SOLICITATION # 36C77624B0021

PROJECT NAME: Patient Aligned Care Team (PACT) Clinic

Building 4 First Floor – Construction – St. Cloud VA Medical Center (VAMC)

TECHNICAL QUESTIONS AND VA RESPONSE TRACKING SHEET

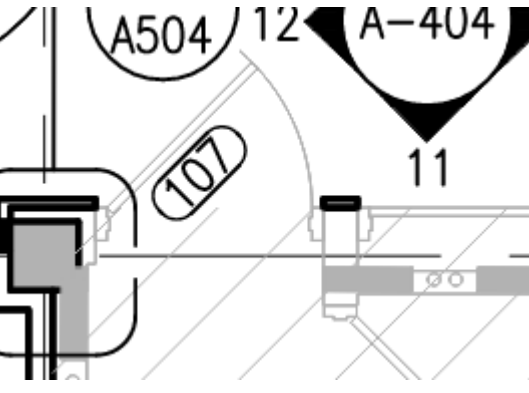
ITEM NO.	DATE QUESTION RECEIVED	DATE QUESTION ANSWERED	QUESTION	GOVERNMENT RESPONSE																																																		
24.	7/26/24	7/29/24	<p>Page A601 there is no hardware group and note #6 indicates to match existing hardware. Please clarify what the existing hardware is so we know what to figure along with the new hollow metal door and frame for this opening.</p>
